OVERALL LANDSCAPE PLAN

LANDSCAPE PLAN

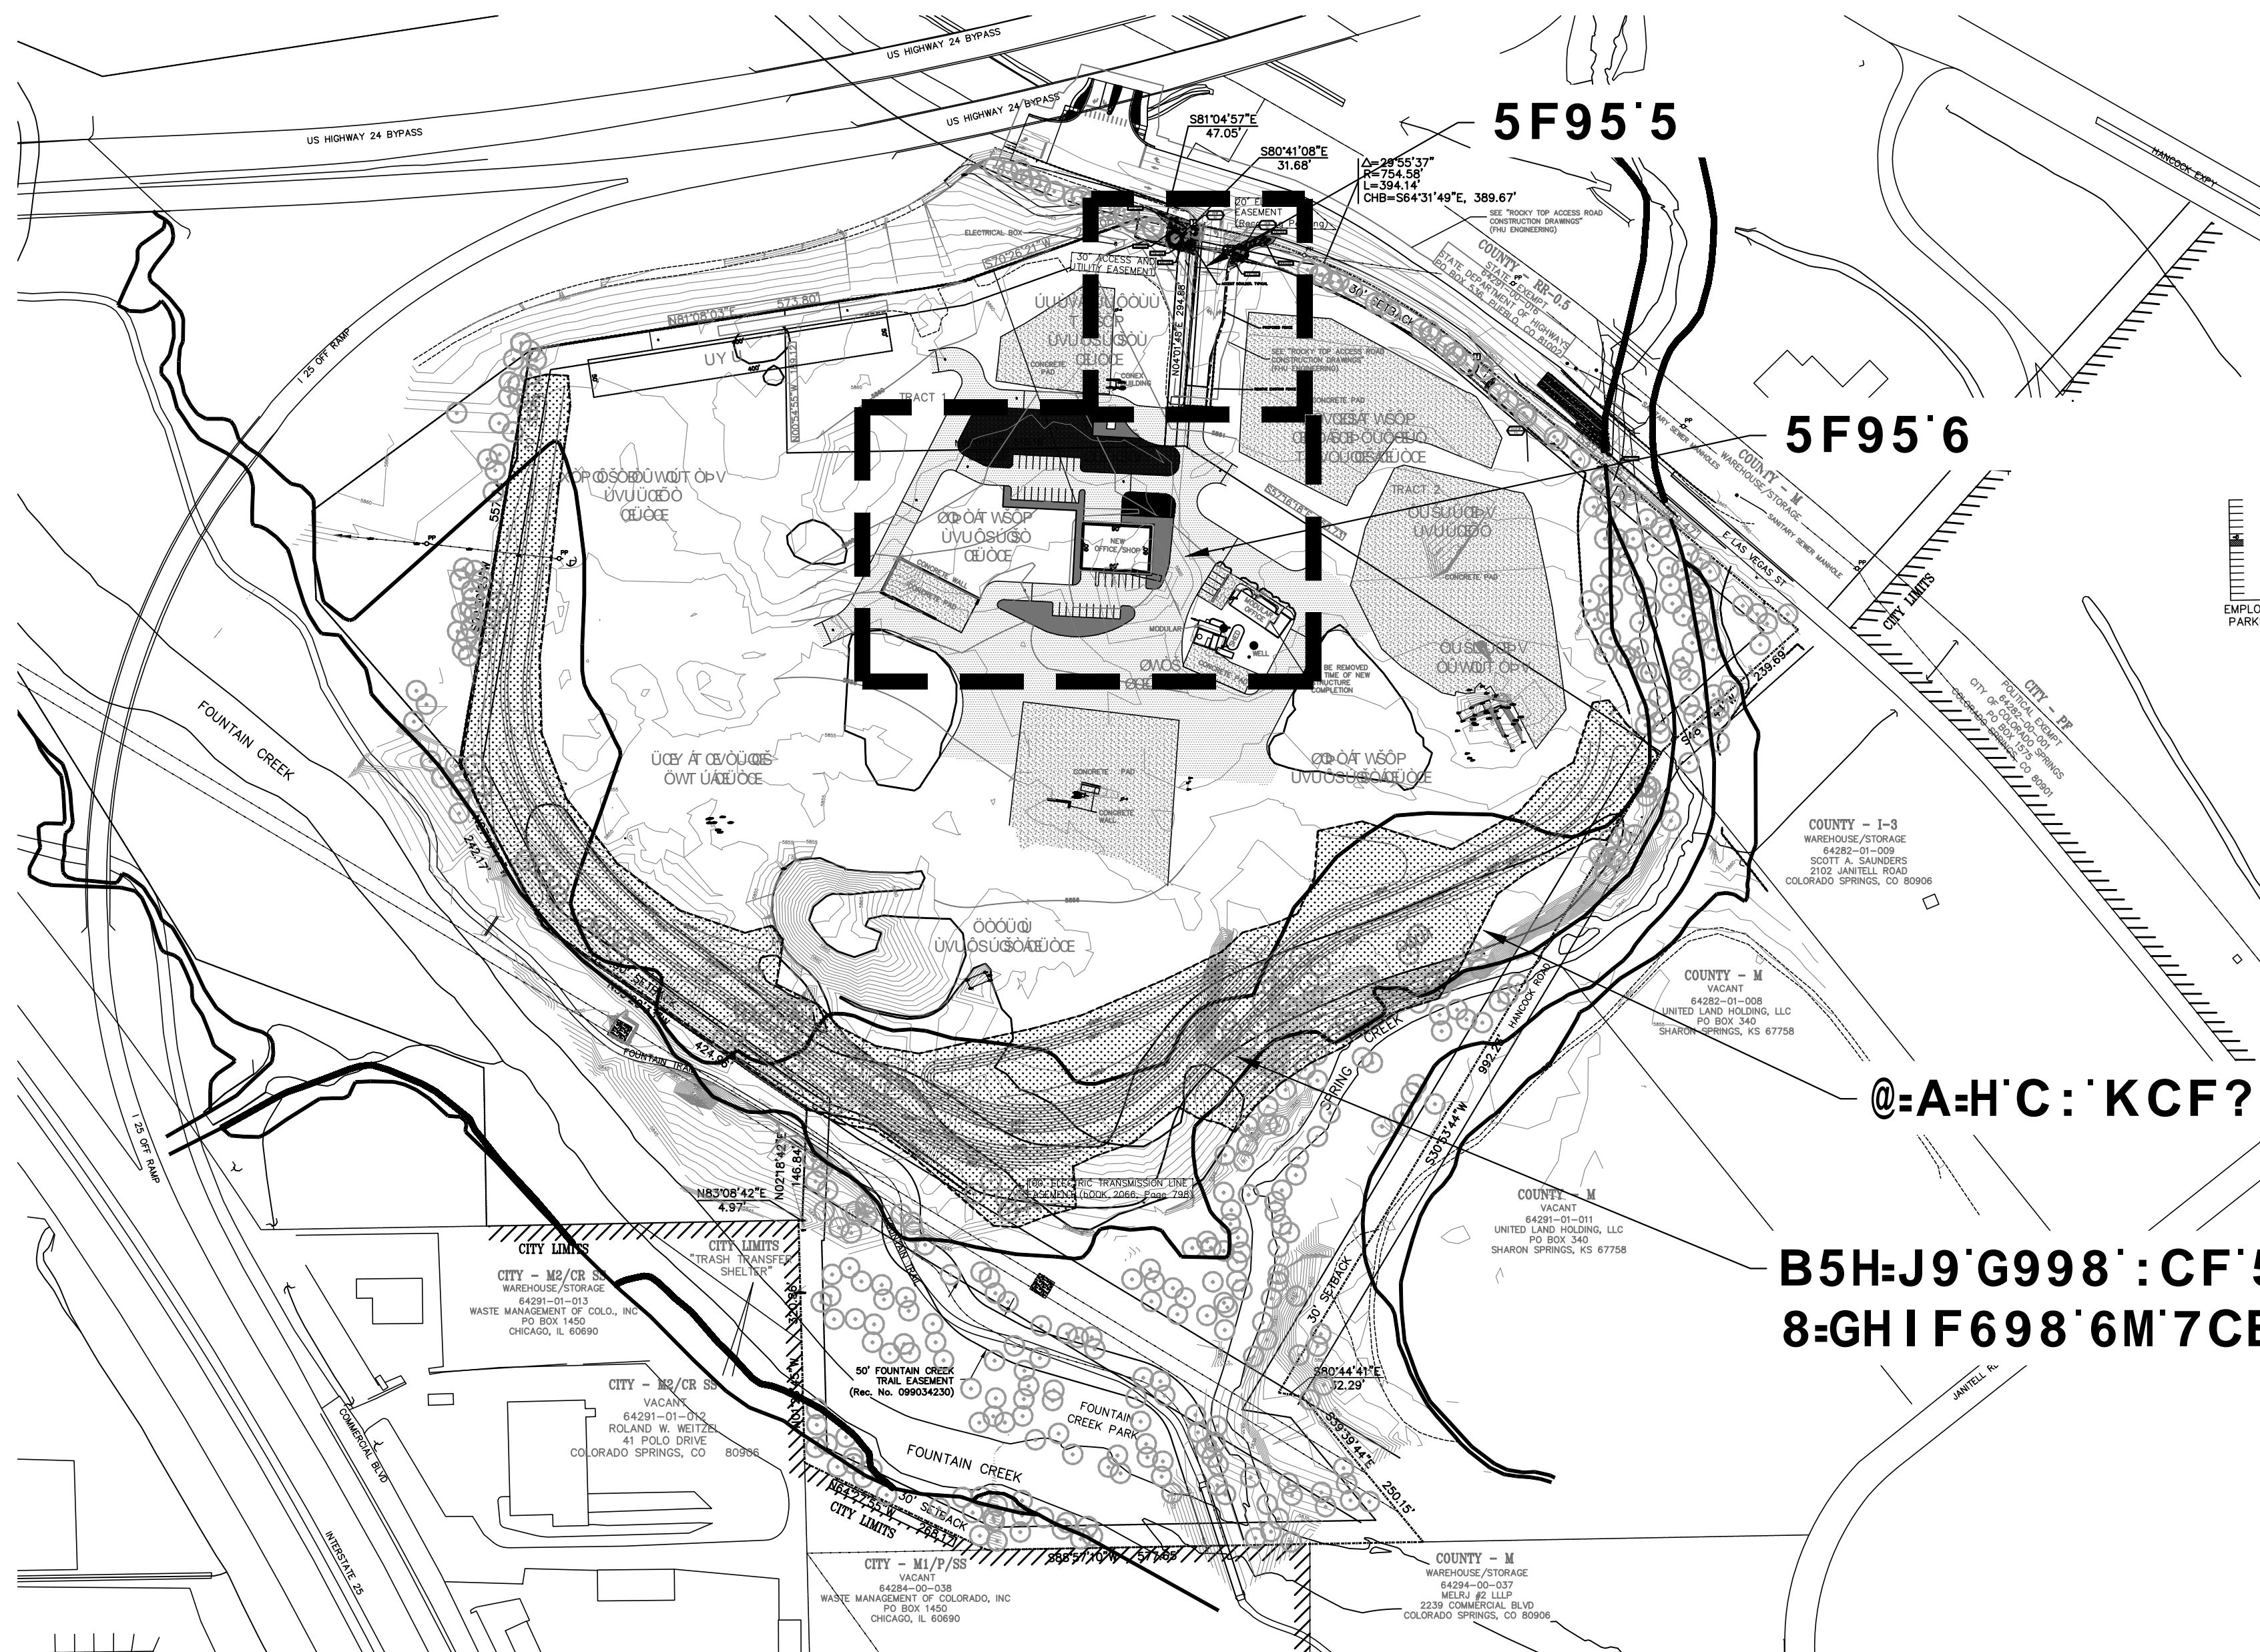
Please indicate that the existing trees are intended to stay.

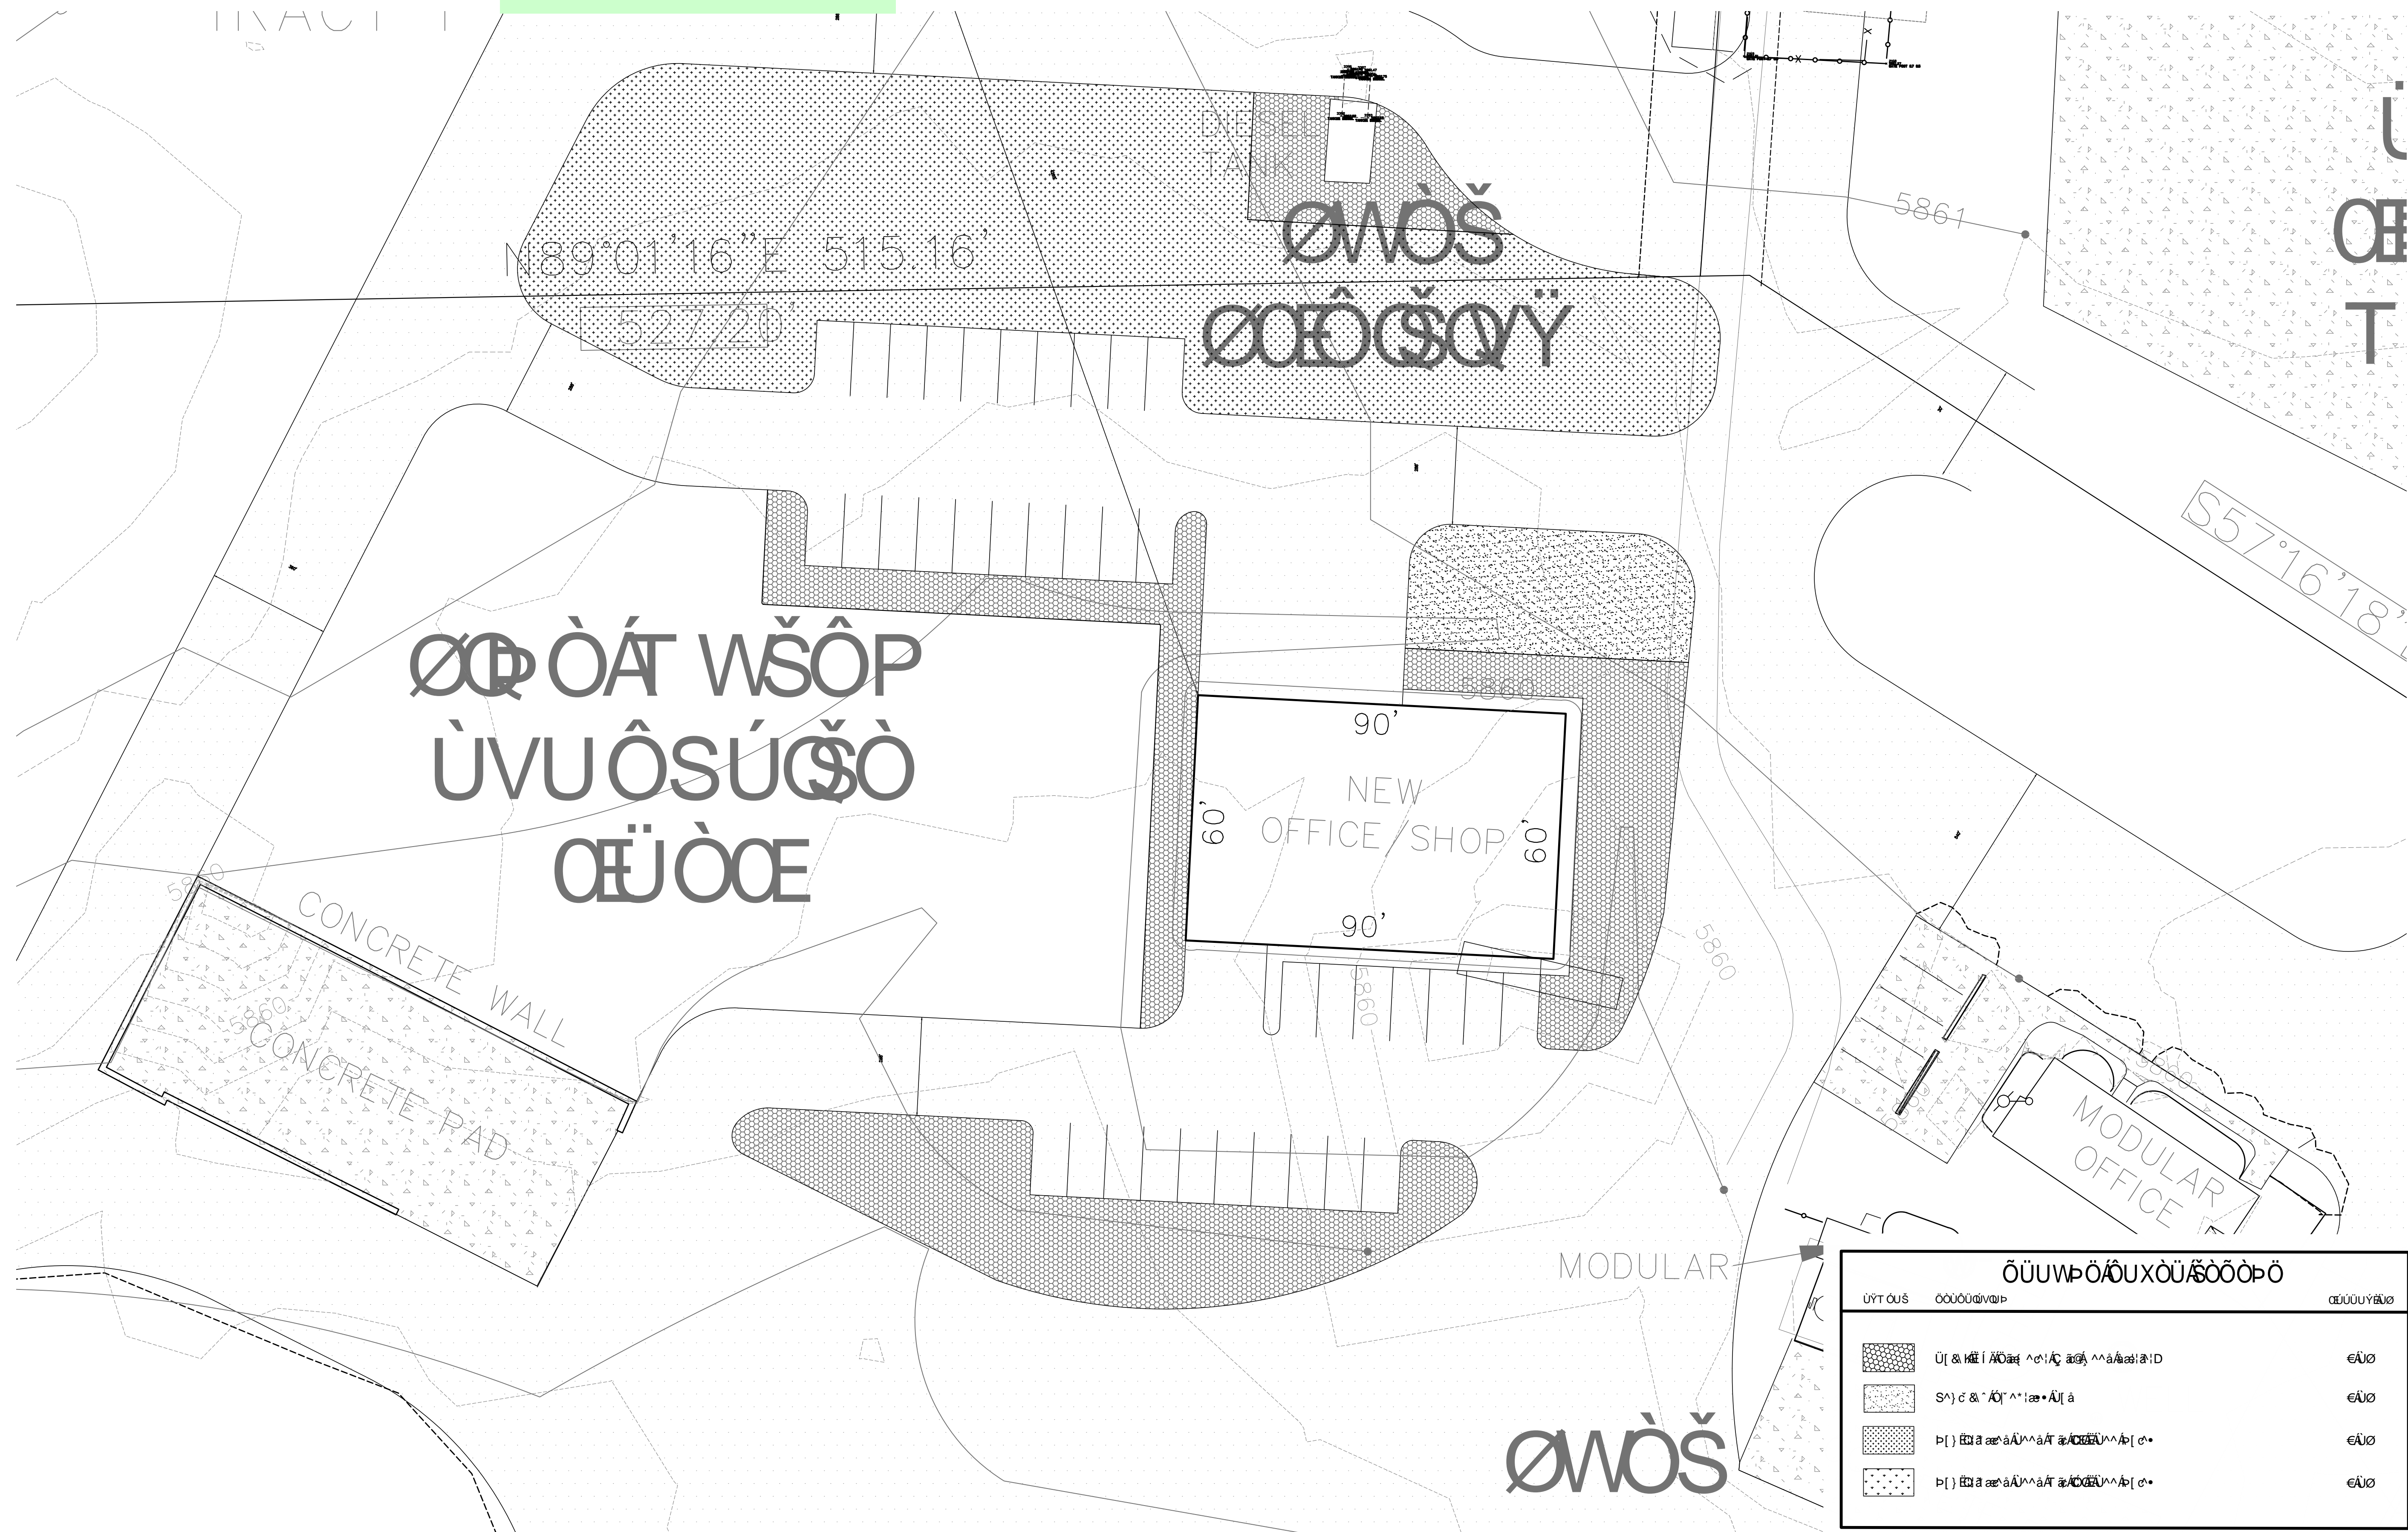
Section 6.2.2(C) Parking Lot Landscape Requirements. There are no trees indicated in this parking lot detail.
